| Stage 4: Draft Self Governance Modification Report | | At what stage is this document in the process? | | | | | | | | | | |
|---|--|--|----|---------------|----|------------------|----|--------------|----|---|----|--|
| <h1 style="color: #00a651; margin: 0;">GC0111:</h1> <h2 style="margin: 0;">Mod Title: Fast Fault Current Injection specification text</h2> |

<table><tr> <td style="width: 30px; text-align: center;">01</td> <td style="padding: 5px;">Proposal Form</td> </tr><tr> <td style="text-align: center; background-color: #00a651; color: white;">04</td> <td style="padding: 5px; background-color: #00a651; color: white;">Draft Self Governance Modification Report</td> </tr></table>

GC0111 aims to update the Grid Code with revised text for fast fault current injection to dispel any confusion in interpretation of the existing text.

Figure 5.0

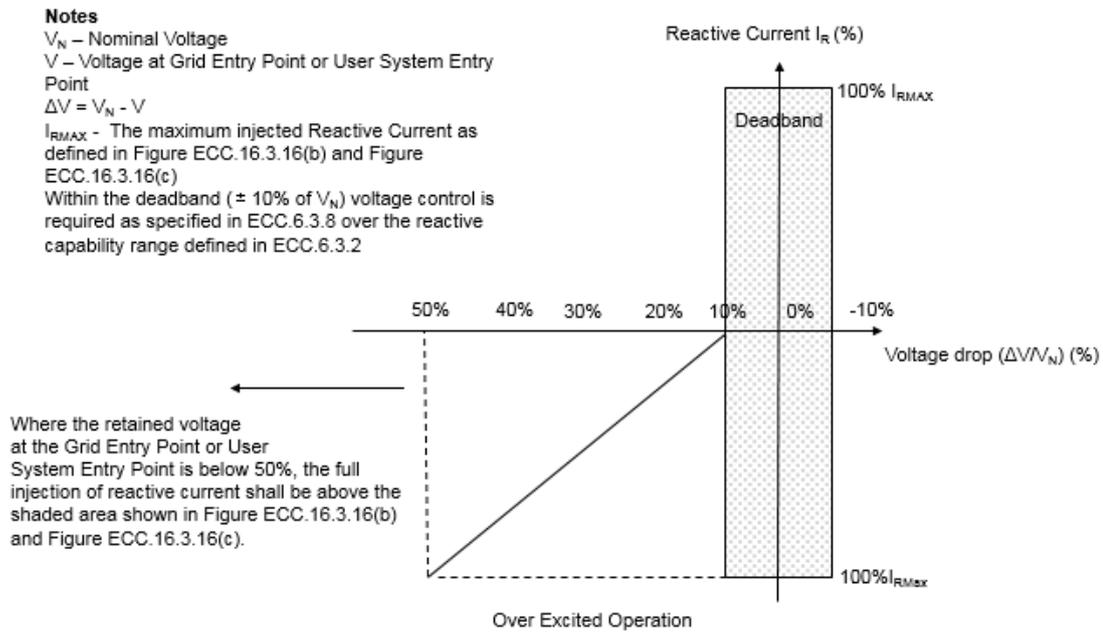
These concepts were further explored and presented to the workgroup in September 2018, which resulted in the following revised voltage / reactive current diagram shown in Figure 5.0.

In addition, corresponding legal text was also developed. At this stage, a number of Workgroup members expressed concern over the behaviour of Power Park Modules and HVDC Systems during unbalanced faults and that the performance of plant can vary quite significantly between full converter based plant or DFIG derived equipment. A number of concerns were also expressed with regard to operation between steady state and under faulted conditions.

Figure 15.0

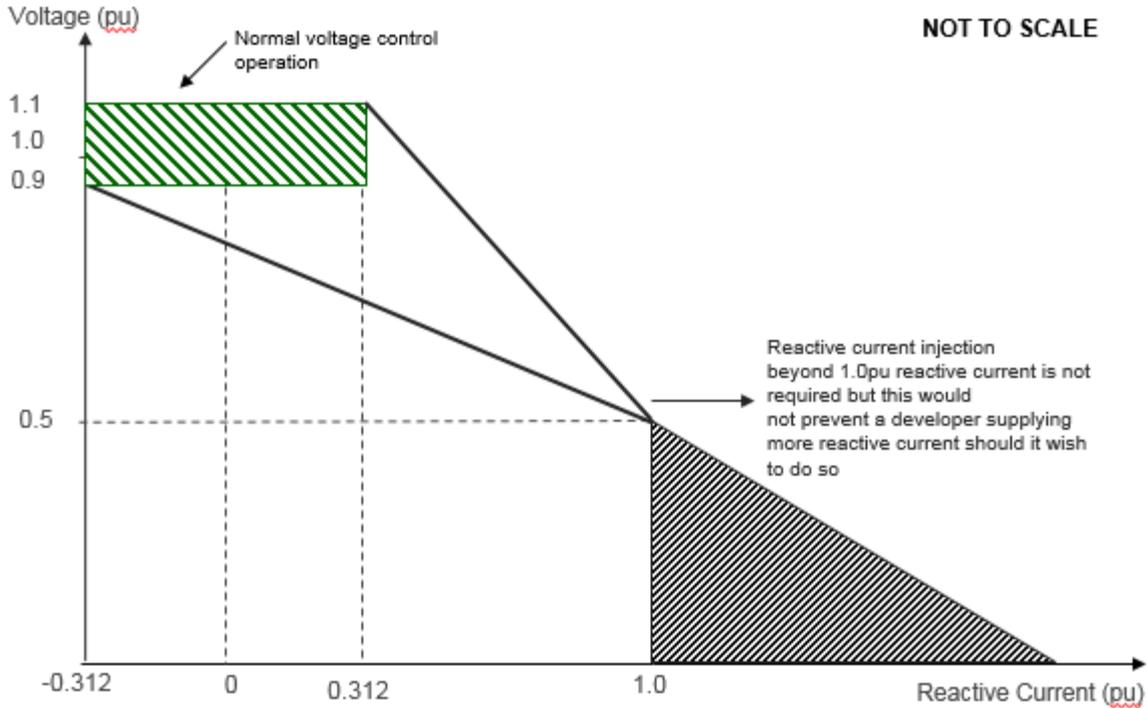
The problem with this approach is that some developers and manufacturers could struggle with the requirement especially in the common case for distribution connected modules if the plant was operating in power factor control mode or reactive power control mode and the Connection Point Voltage remained at 0.9pu and the generator was operating under full import – although such an operating point itself is not likely. To address this issue, it was suggested at the February 2019 Workgroup meeting that the normal voltage operating envelope should be retained and an envelope of operation defined between the two black lines (ie starting at the extreme ends of the voltage

In this case, the point was raised that a plant could be operating at 0.9 power factor in a leading mode of operation at 0.9 pu voltage which could only apply in a power factor or reactive power mode of operation and even then in the unlikely event this were to occur, the voltage would have to drop for a small amount even to get zero injection of reactive current although there would be a delta change (i.e. the difference between the final reactive current injection and the pre-fault reactive current injection) in transiting from a fully leading power factor to unity.

To address this concern, two points were raised. The first, that irrespective of the operating point within the normal voltage operating range, the locus of I_R should converge to the 0.5pu voltage / 1.0pu reactive current coordinate so as not solely to give a minimum performance requirement. Secondly, some concern was expressed as to how this requirement would interface with Figures ECC.6.3.16(b) and ECC.6.3.16(c). A comment was also noted that the upper boundary would not be required.

Figure 16.0

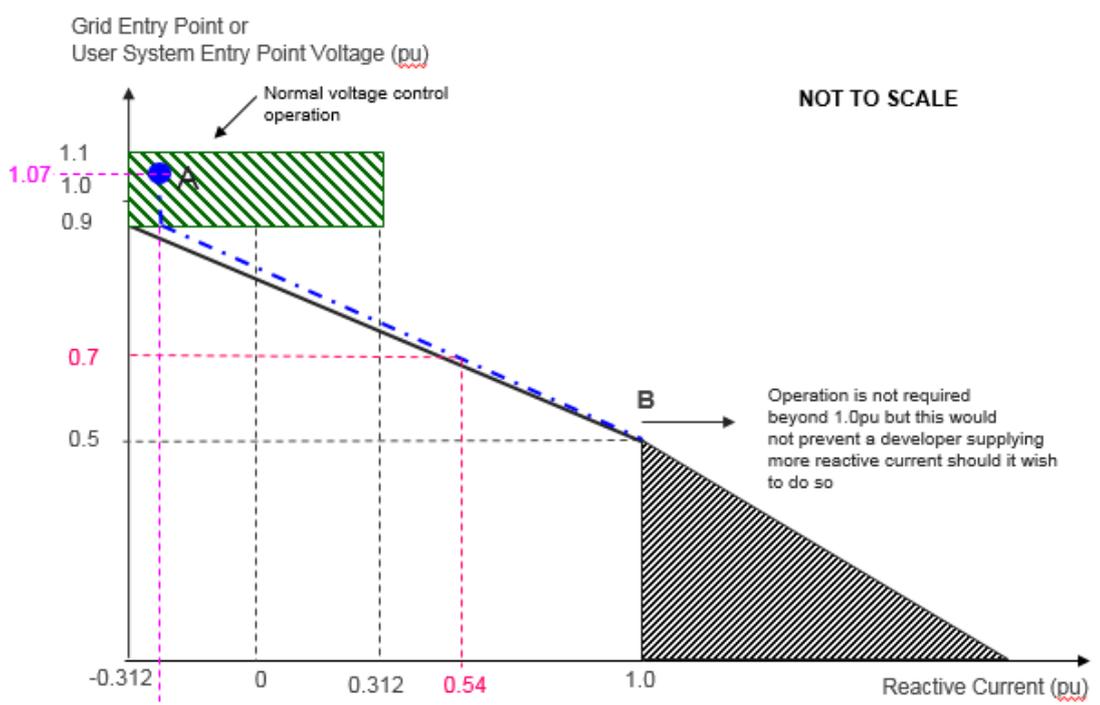
Figure 16 shows an illustrative requirement of the behaviour expected from a plant operating in the leading mode of operation and the I_R value required when subject to a voltage dip of 0.7pu at the connection point.

For the purposes of this example we are assuming the Power Park Module is exposed to a voltage dip of 0.7 pu. At 0.7pu voltage this corresponds to I_R of 0.54 pu reactive current as shown by the purple dashed line and where it intersects with the blue dashed line. I_R would need to be greater than or equal to 0.54.

Figure 19.0

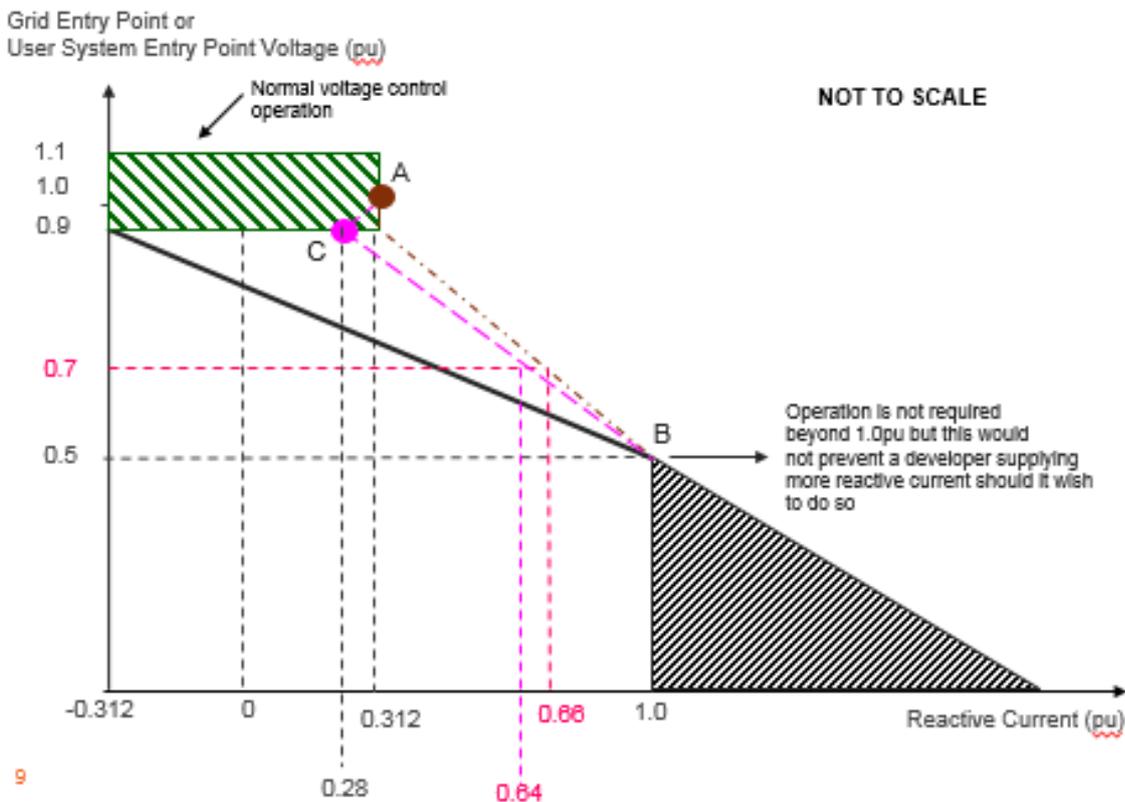
In this case, the pre-fault operating condition is assumed to be arbitrarily operating at 0.96pu voltage and the reactive current is 0.312pu. This is shown by the brown circle in the green shaded area. Applying the same approach as in example 1, the brown dotted line constructed between points A and B of Figure 19 indicates the I_R required as a function of the retained voltage. However we need to ensure that the rating of the plant is not exceeded and therefore an additional pink line at point C is drawn. This reduction is permitted as the Grid Code requires full reactive capability to be provided over a voltage range of 1.05pu to 0.95pu. Below 0.95pu voltage, a drop in the reactive power export is

For the purposes of this example, we are assuming the Power Park Module is exposed to a voltage dip of 0.7 pu. At 0.7 pu voltage this corresponds to a I_R of 0.64 pu reactive current as shown by the purple dashed line and where it intersects with the pink dashed line at 0.7pu voltage.

Figure ECC.6.3.16(a)

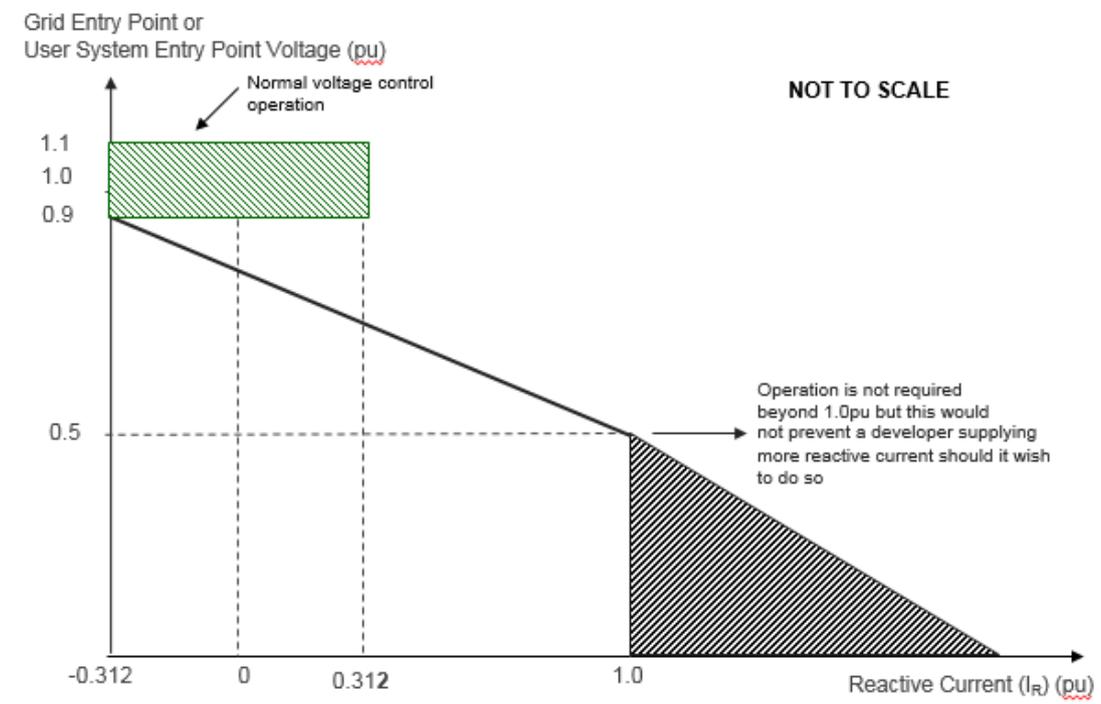
ECC.6.3.16.1.3 Figure ECC.6.3.16(a) defines the reactive current (I_R) to be supplied under a faulted condition which shall be dependent upon the pre-fault operating condition and the retained voltage at the **Grid Entry Point** or **User System Entry Point** voltage. For the avoidance of doubt, each **Power Park Module** (and any constituent element thereof) or **HVDC Equipment**, shall be required to inject a reactive current (I_R) which shall be not less than its pre-fault reactive current and which shall as a minimum increase with the fall in the retained voltage each time the retained-voltage at the **Grid Entry Point** or **User System Entry Point (if Embedded)** falls below 0.9pu whilst ensuring the overall rating of the **Power Park Module** (or constituent element thereof) or **HVDC Equipment** shall not be exceeded.

Figure ECC.6.3.16(b)

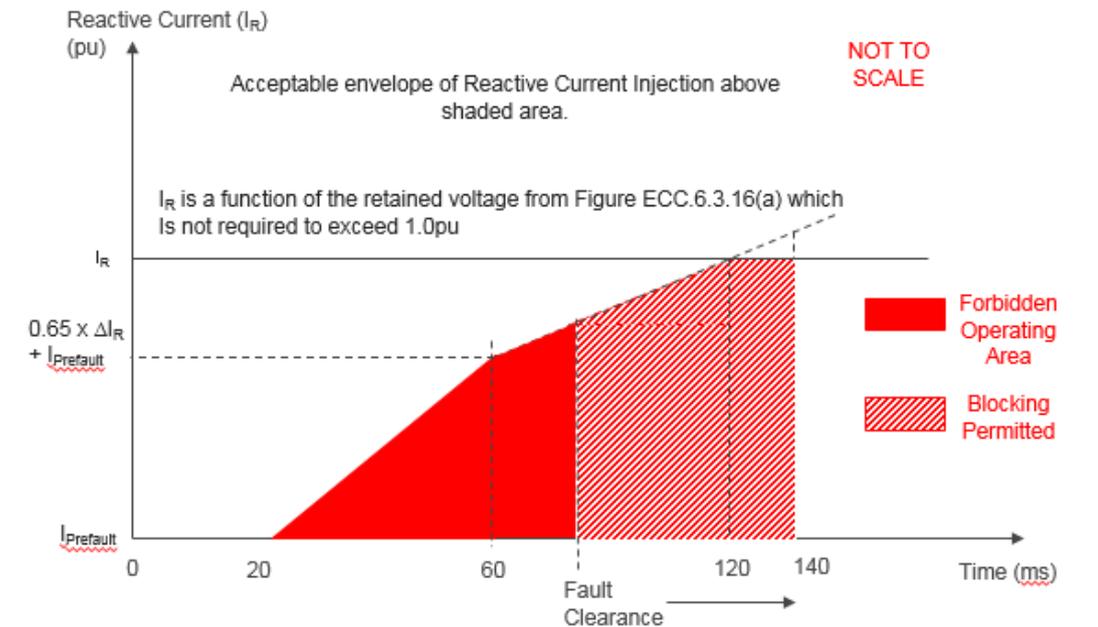
ECC.6.3.16.1.5 The injected reactive current (I_R) shall be above the shaded area shown in Figure ECC.6.3.16(b) and Figure ECC.6.3.16(c) with priority being given to reactive current injection with any residual capability being supplied as active current. Under any faulted condition, where the voltage falls outside the limits specified in ECC.6.1.4, there would be no requirement for each **Power Park Module** or constituent **Power Park Unit** or **HVDC Equipment** to exceed its transient or steady state rating of 1.0pu as defined in ECC.6.3.16.1.7.

Figure ECC.A.4.2

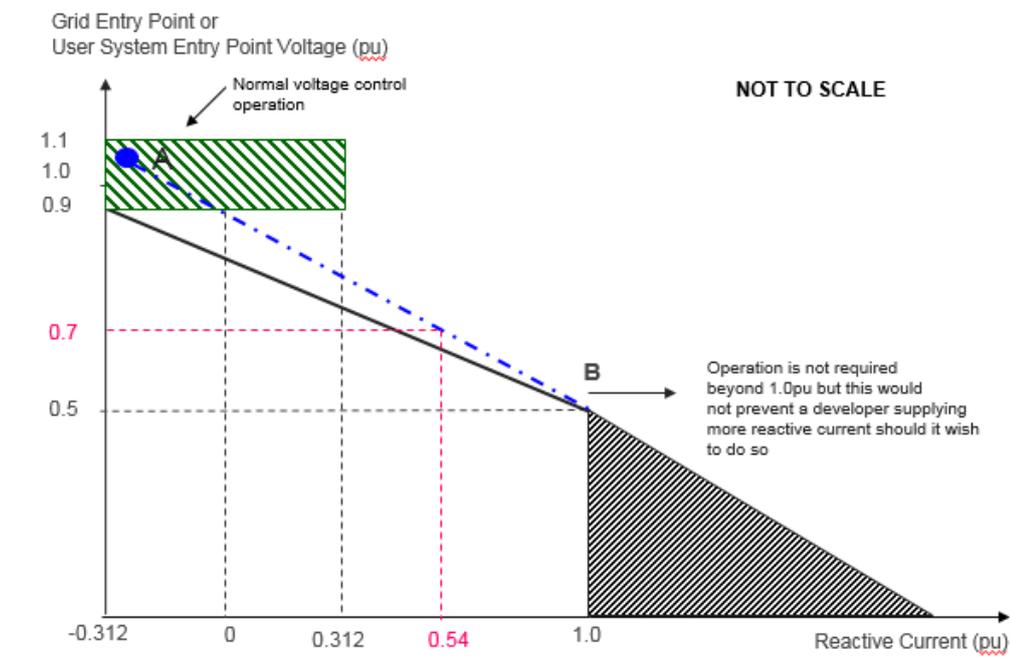
ECC.A.4EC1.4 Figure ECC.A.4.2 is an adaptation of Figure ECC.6.3.16(a) in which the pre-fault operating point is shown by point A in the rectangular shaded area. The trajectory from the initial operating point (point A) to the intersection at 0.5pu voltage and 1.0pu reactive current (point B) is shown by the dashed line. For the purposes of this example it is assumed that the wind farm is exposed to a voltage dip of 0.7 pu at the **Grid Entry Point**. At 0.7pu voltage this intersects line AB giving a reactive current injection of 0.54 pu reactive current which requires the **Power Park Module** to supply a reactive current (I_R) of 0.54pu or greater with any residual current being supplied as active current.

Figure ECC.A.4.5

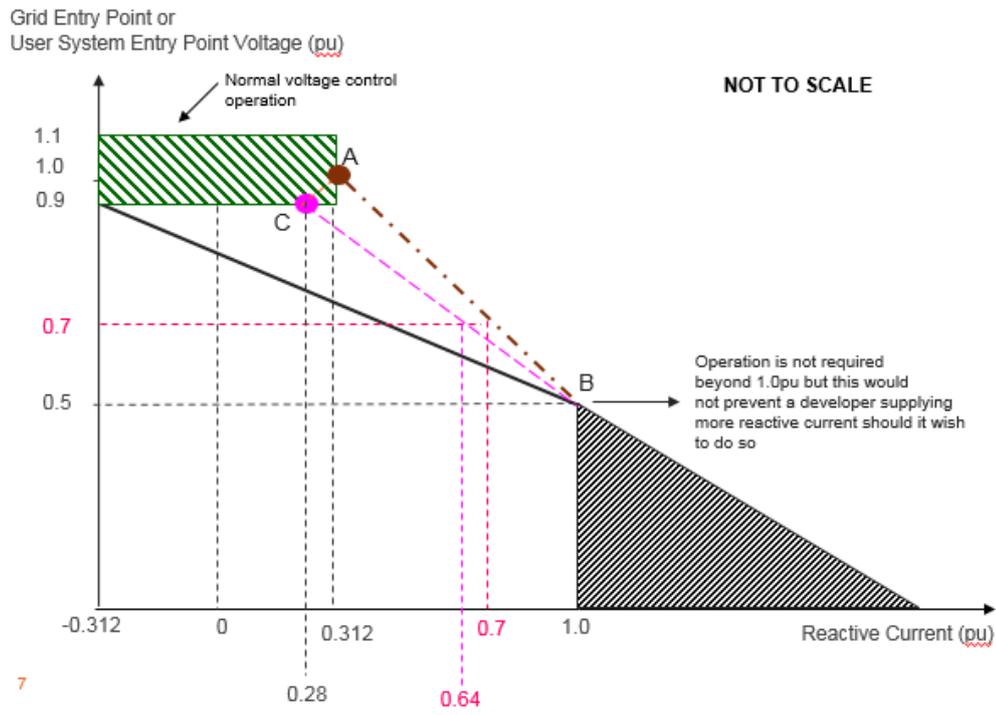
ECC.A.4EC1.6 In the second example, Figure ECC.A.4.5 is an adaptation of Figure ECC.6.3.16(a) in which the wind farm is now operating in the lagging mode of operation. The wind farm is operating at a **Grid Entry Point** voltage of 0.96pu voltage and a reactive current (I_R) of 0.312 pu export. The pre-fault operating point is shown by point A in the rectangular shaded area. The trajectory from the initial operating point (point A) to the intersection at 0.5pu voltage and 1.0pu reactive current (point B) is shown by the dashed line. For the purposes of this example it is again assumed that the wind farm is exposed to a voltage dip of 0.7 pu at the **Grid Entry Point**. At 0.7pu voltage this intersects line AB giving a reactive current injection of 0.7 pu reactive current. However it is important to recall that the rating of the wind farm should not be exceeded which is shown by revised line CB shown in Figure ECC.A.4.5. The effect of this is important as it means that the reactive current (I_R) supplied should be reduced from 0.7pu to 0.64pu.
